# RECREATION AND SCHOOL STORAGE BARN

39 Town Farm Road

Year Constructed:  
Year of Renovation/Addition:  
Building Type: S-2  
Construction Type: VB  
Fire sprinklers: No  
Total Floor Area: 3,500 SF  
Floors: Main, Basement/Garage .  
Assessor Lot # 024 0022 0000

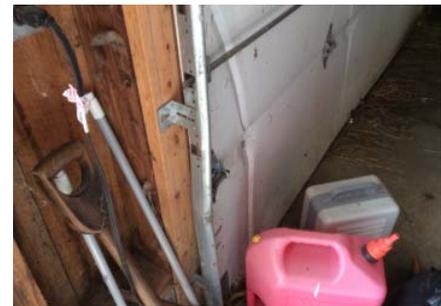
3 Attic louvers are damaged. If building is re-insulated the louvers should be removed and wall patched.

2 Stair to first floor has only one handrail/guardrail. Add new railing with handrails on both sides. Add inverted clapboards to stair risers to eliminate projecting nosings and re-paint stair.
